## HISTORIC DISTRICT REVIEW BOARD WORK SESSION AGENDA

**Agenda Item:** APPLICATION FOR AN ALTERATION, HDRB #25-009, to consider an application for a Certificate of Appropriateness for alterations that include replacement siding, porch columns and railings, windows, entry doors, roof eaves, and asphalt shingle roofing at the single-family residential building located at 820 Locust Street, Herndon, Virginia

## STAFF REPORT

"HISTORIC DISTRICT PROPERTY MODIFICATION"

FRONT AXON (PROPOSED)

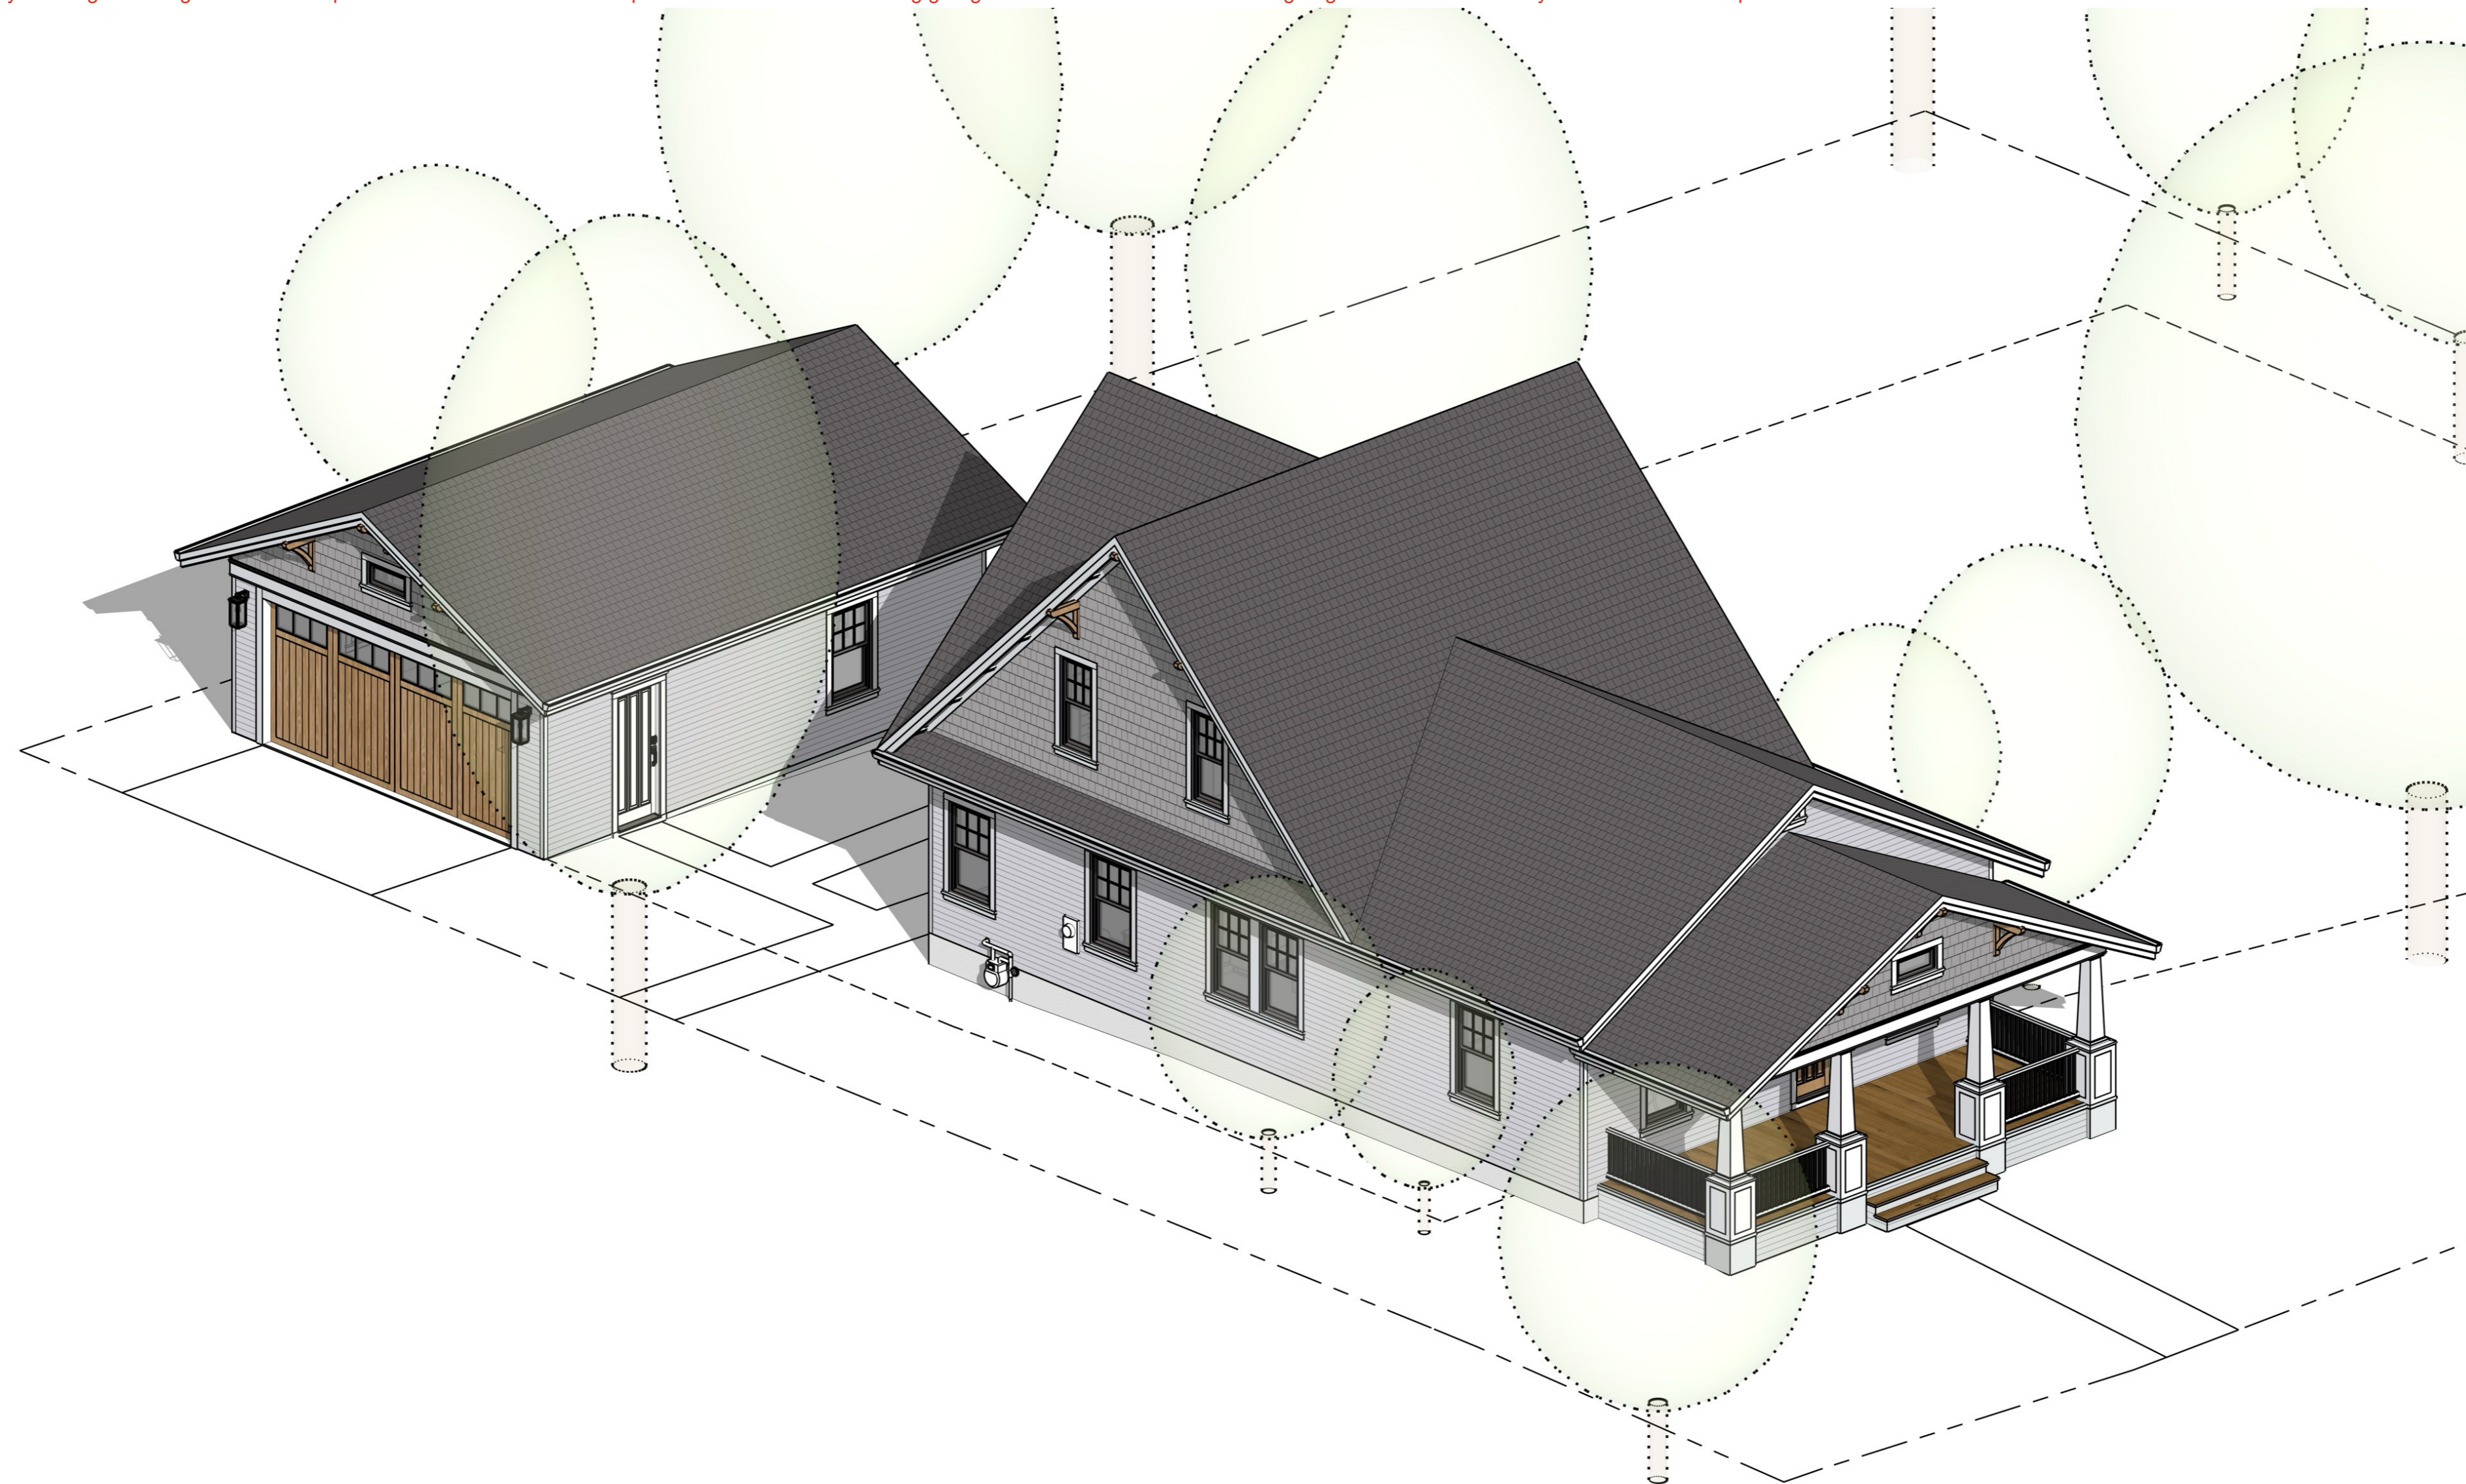
- o The location of the front door is proposed to change, which will alter the balance along the façade and change the focal point from the period of significance.

- The design proposes to add wooden brackets to the eaves on the front elevation of the dwelling. This constitutes an added ornament to a portion of the dwelling that dates to the period of significance, which goes against the guidelines (p. 67).

- o This design also proposes to add brackets to the eaves on the cross-gable, which dates to the 1998 addition. This change is consistent with the guidelines in that the ornamentation is being added to a modern addition (p. 67).

REAR AXON (PROPOSED)

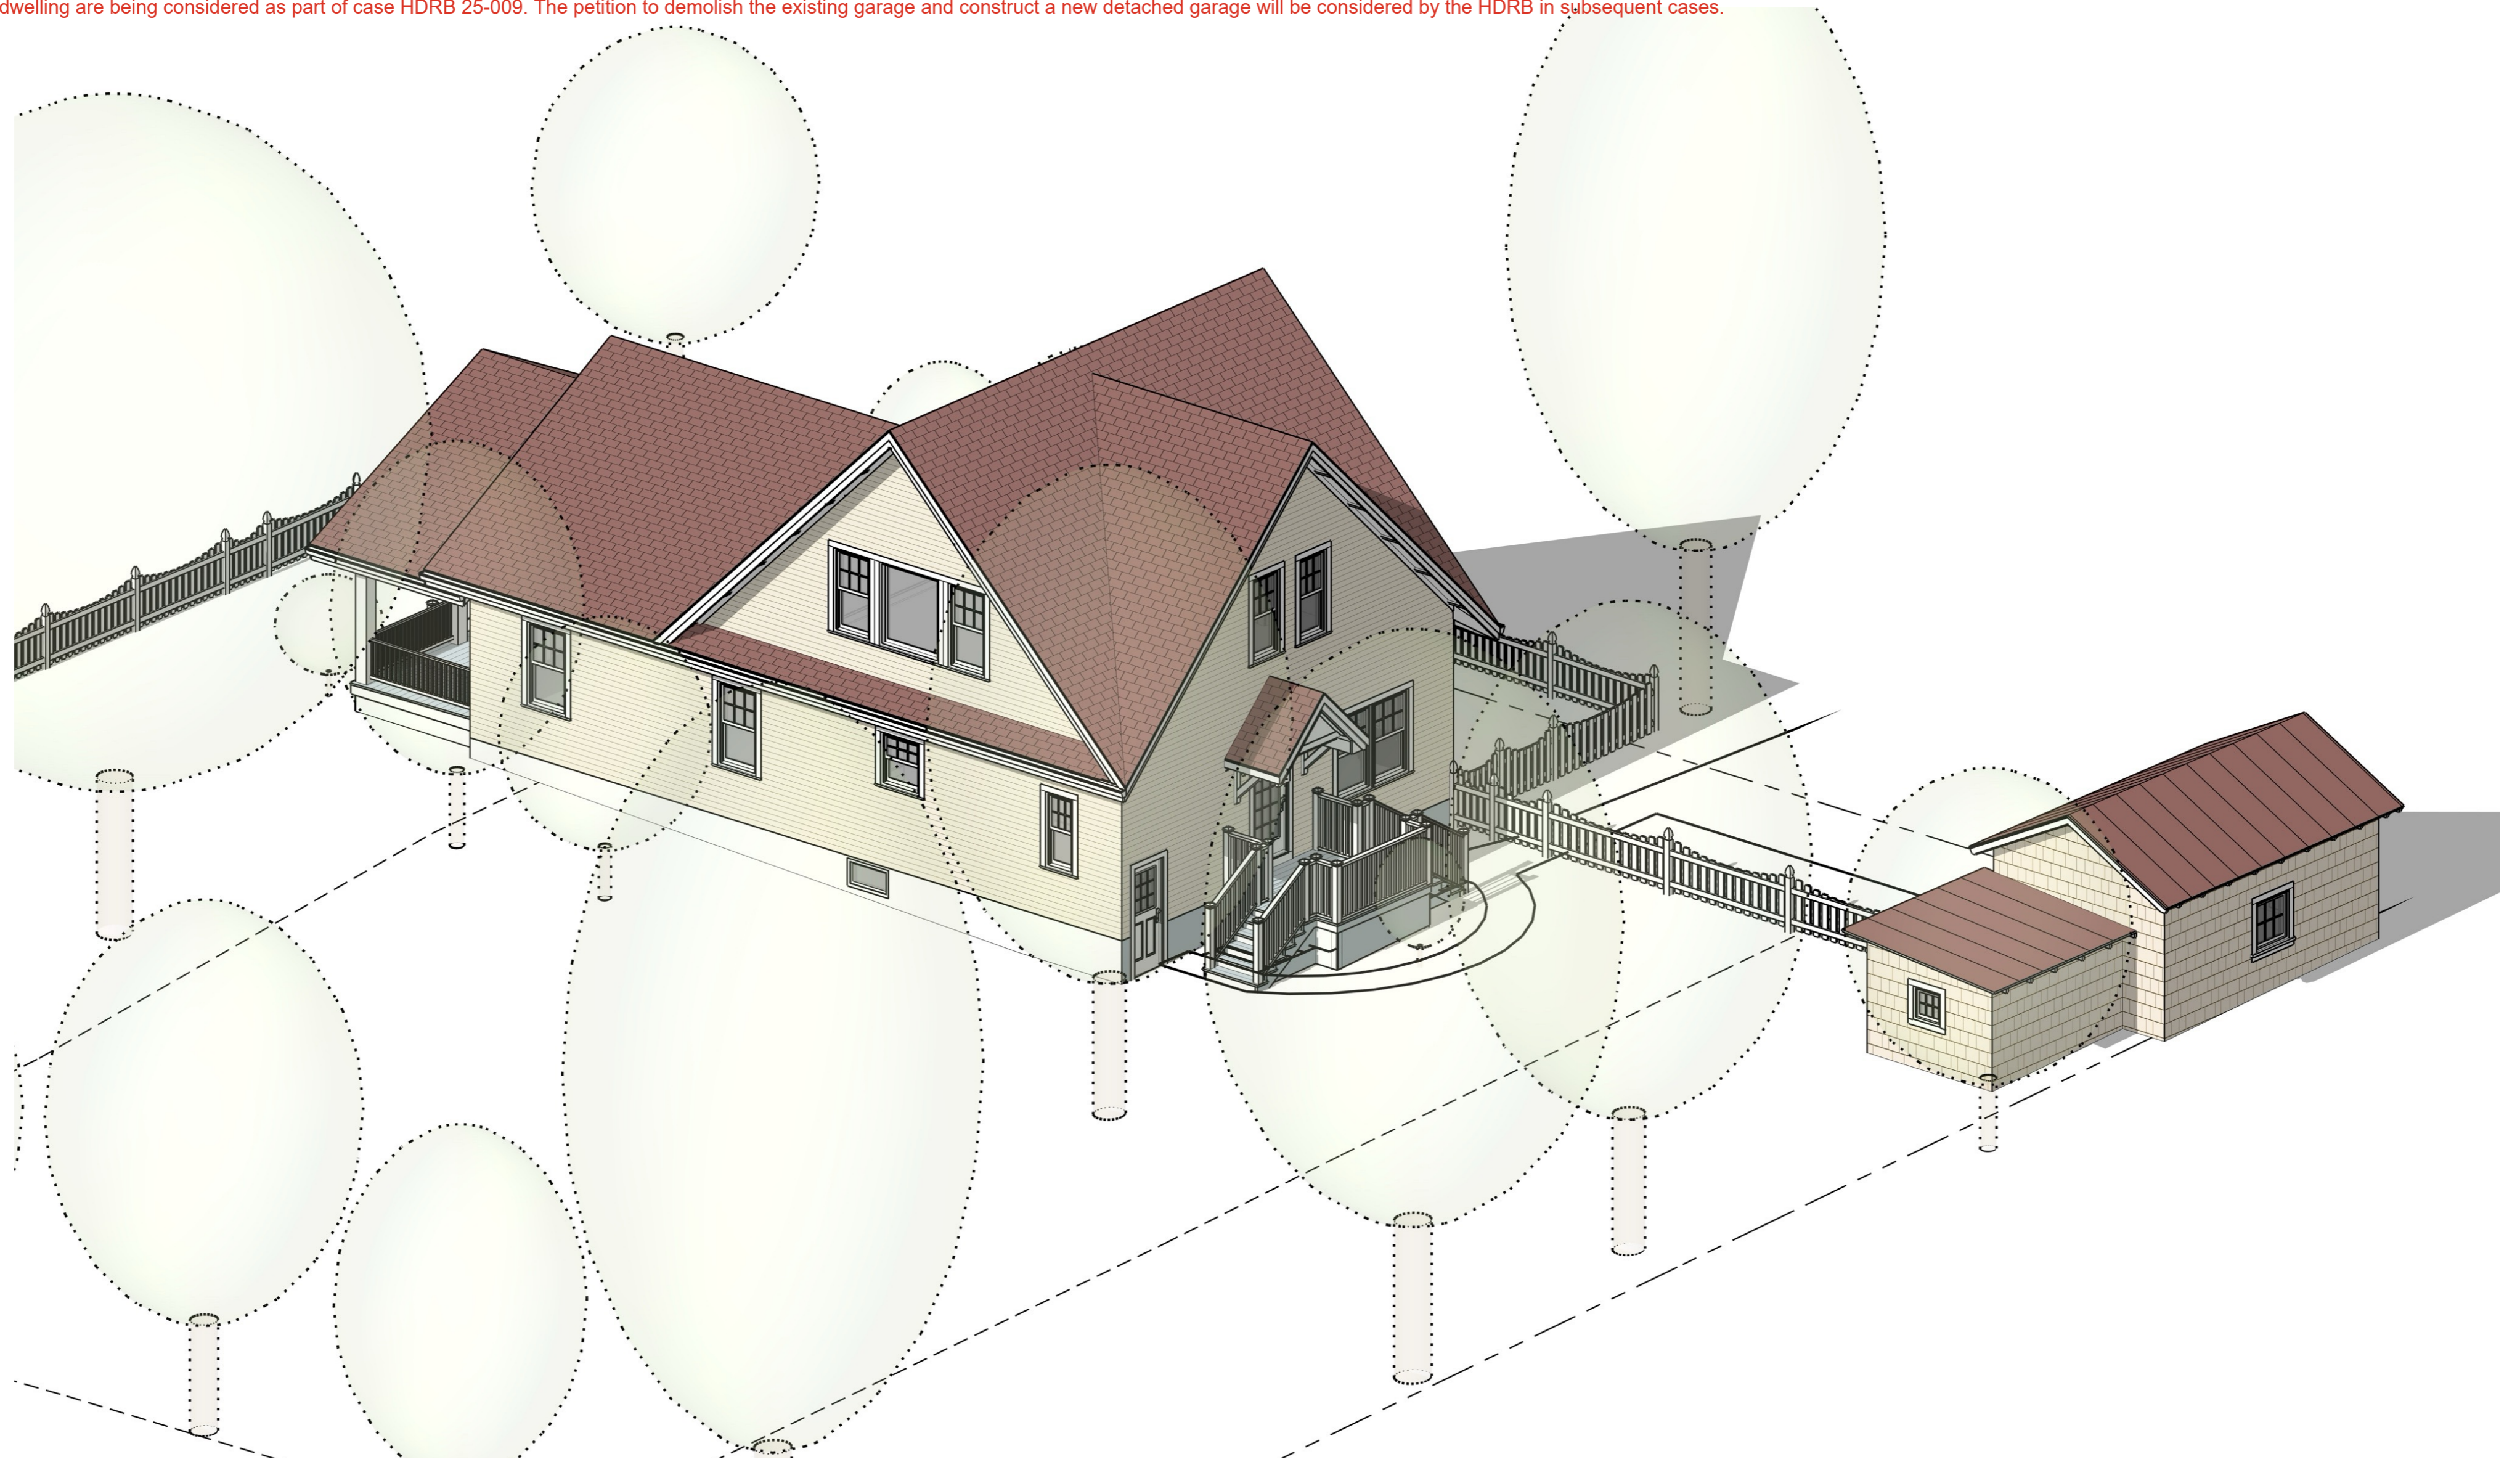
- o Note that the addition of the large transom window above the existing compound window within the gable end of the east side elevation will add a penetration to the 1998 addition to the dwelling. The guidelines support such changes to modern additions (p. 61).
